ALAMEDA COUNTY
HEALTH CARE SERVICES

Subject: Fuel Leak Case No. ~~EC0000488~~, Laidlaw Transit (Maintenance Yard), 2900 Ladd Avenue, Livermore, CA

TECHNICAL COMMENTS

FIGURE NO. **1**
 JOB NO.: 3174-F7
 DATE: JULY 1994
 DRAWN BY: [Signature]
 CHECKED BY: [Signature]

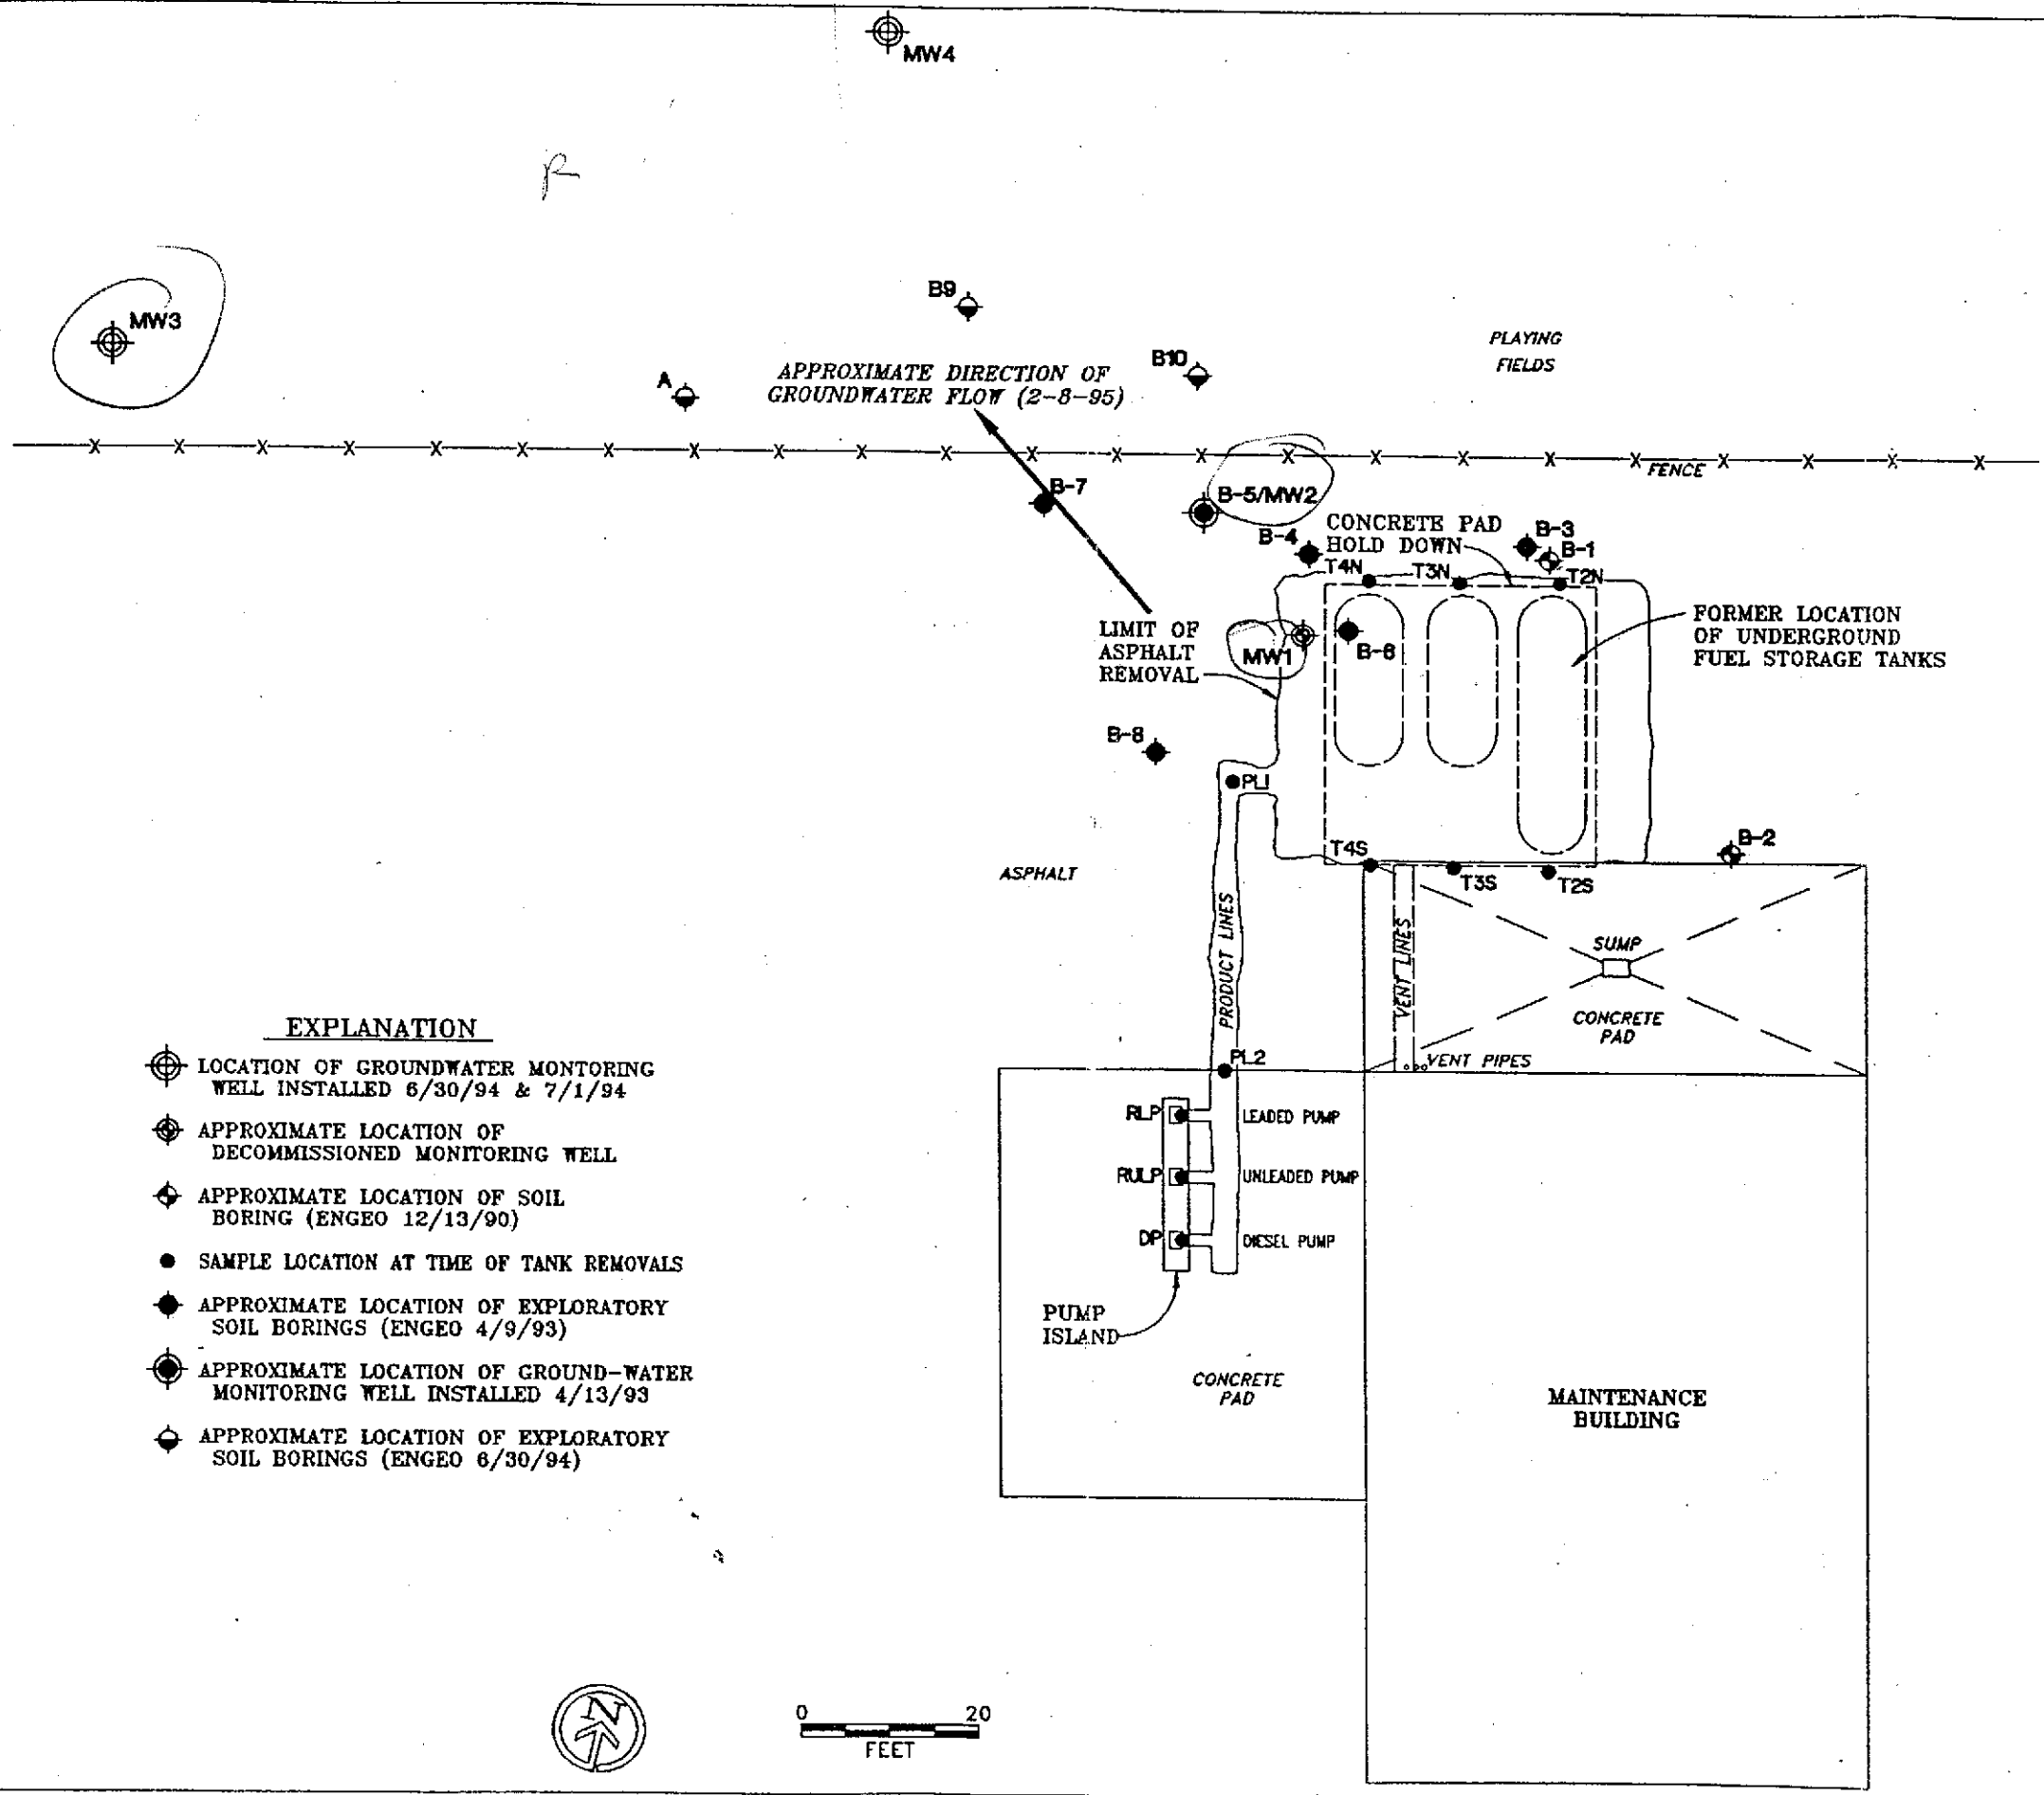
① Can do 10^{-5} risk ✓
 ② Include grab water samples from soil being (onsite) into calc. of representative conc. if samples were < 20' by - verify w/ the wells mo-8, mo-9 near this location
 ③ Use soil conc from samples collected ≤ (above) 20' by
 ④ Should mo-2 only be used for GW data for ONSITE volat from gw to indoor air -
